**IMPORTANT SAFETY RECALL NOTICE**  
**Lippert Window Recall Campaign 21E-047**  
**NHTSA #21V644**  
**September 2021**  
**THIS NOTICE APPLIES TO YOUR VEHICLE**

# HEHR 6400 SERIES WINDOW VENT RECALL

Recall Number:	21E047		
Product:	Hehr 6400 Series Window Vent		
Date:	June 29, 2021	Labor Rate:	Inspection 0.4 hour per unit Replacement 0.5 hour per vent

Fig. 5

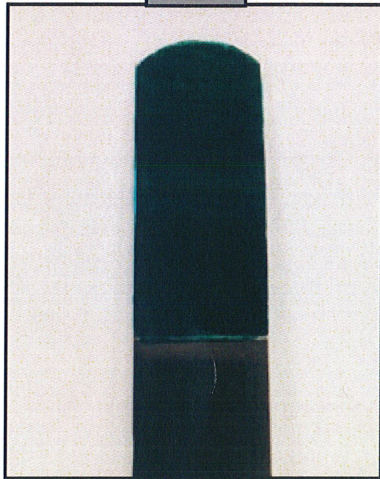
The provided gauge has a colored segment at one end (Fig. 5). Use the gauge as outlined in the instructions below to determine any possible break in the seal.

Fig. 6

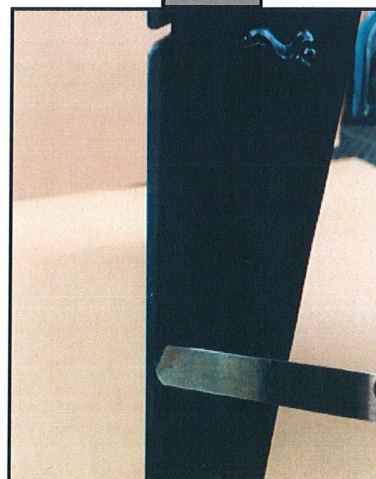
1. Be sure window is in closed position.
2. Lightly insert the gauge into the gap between the glass and the frame (Fig. 6) starting near the hinge on the exterior side of the window.
3. The gauge should stop within the colored segment (Fig. 7).
4. Continue reinserting the gauge at different points, working around the glass.

Fig. 8

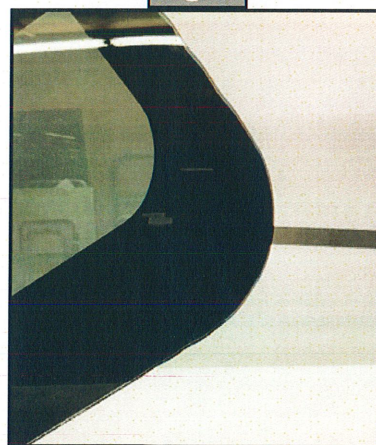
**NOTE:** If the gauge inserts beyond the colored segment (Fig. 8) this indicates a possible break in the seal and the vent of the window will need replacing.
